STORM DRAINAGE (DETENTION) WATER QUALITY

AS-BUILT APPROVED AS NOTED

DRY DETENTION AS-BUILT
COORDS: 1434131, 514532 (NAD83)

AS BUILT	
BMP Inset Table Extended Dry Detention	
Project Name:	PetSuites Archdale
Sequence ID:	1
Surface Area (sq. ft.):	4,700 SF - 6,670 @ 681'
Drainage Area (acres):	4.09
Land Use/Development Type:	commercial light
Percent Built-Up Area:	36%
Maximum Depth (ft.):	4
Detention Basin Type:	Surface
Forebay Present (Y/N):	yes
Flow Diverters Present (Y/N):	No
Regulated By:	Post Construction
Treatment Effectiveness:	Standard
NC State Plane X (easting):	1434114.47
NC State Plane Y (northing):	514550.1

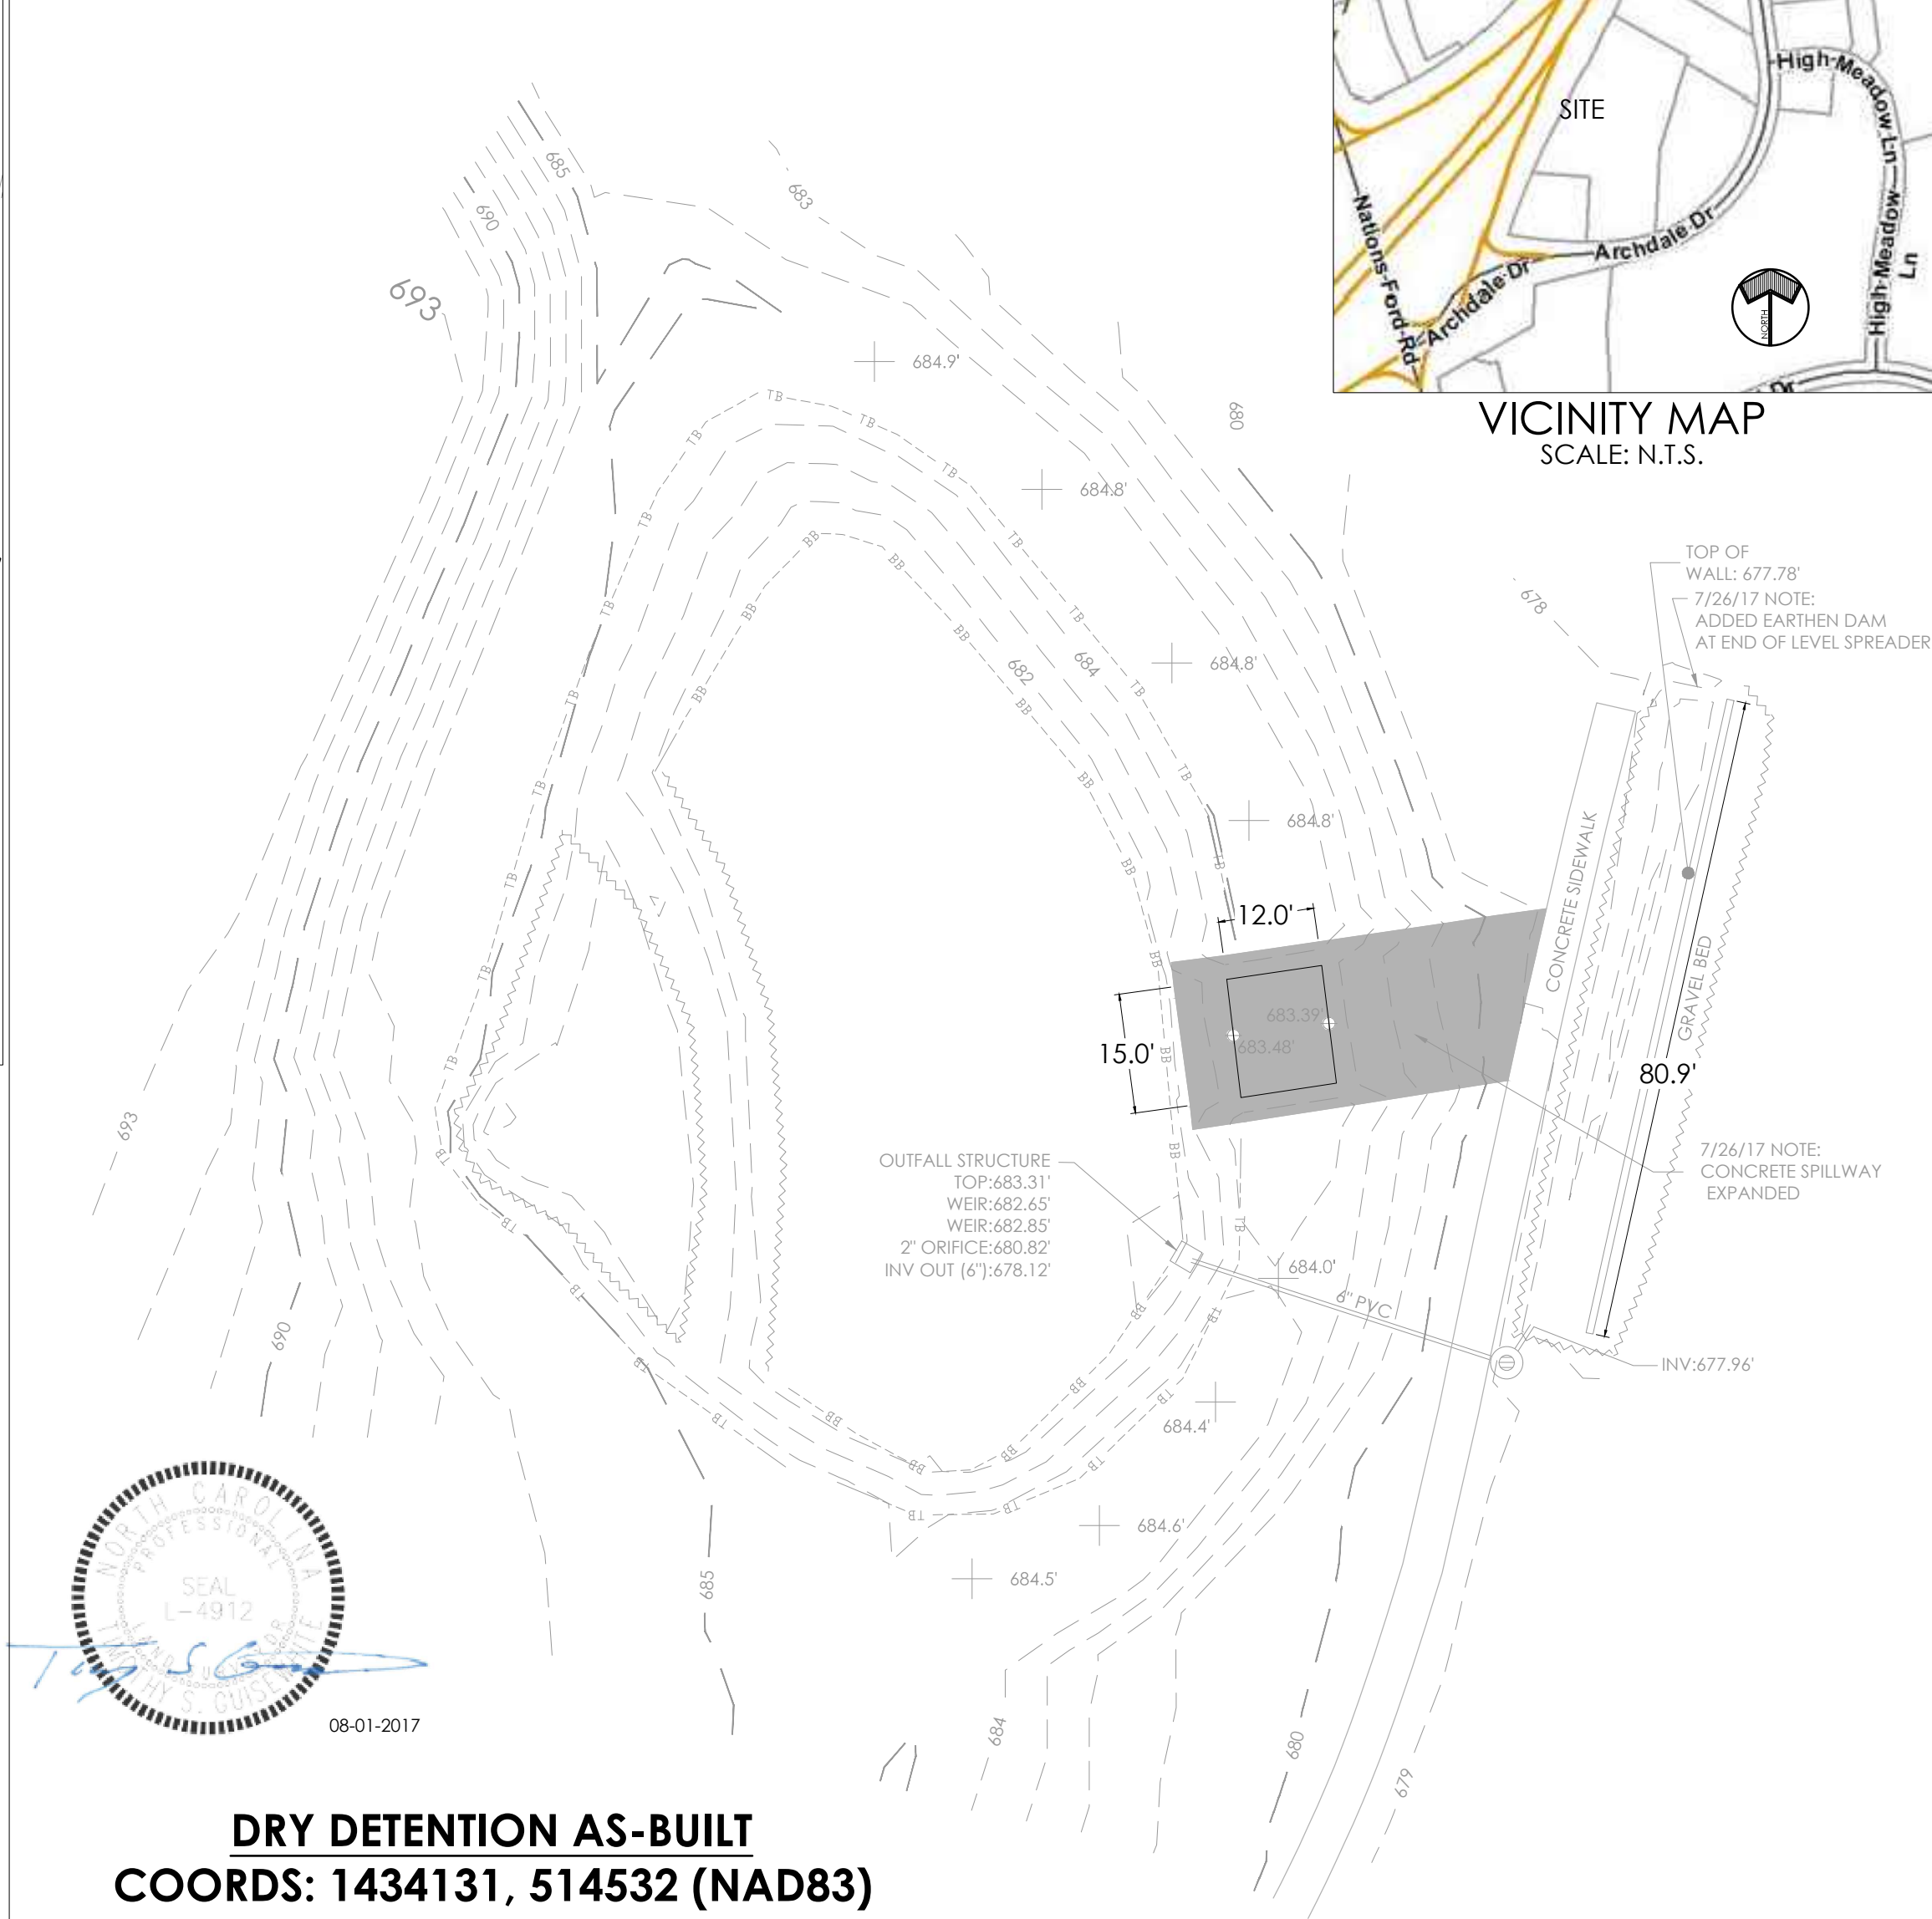
-A BUA AS-BUILT SHALL BE PROVIDED PRIOR TO THE ISSUANCE OF BMP AS-BUILT APPROVAL.

-LS WILL BE INCLUDED BMP AS-BUILT PRIOR TO CO RELEASE.
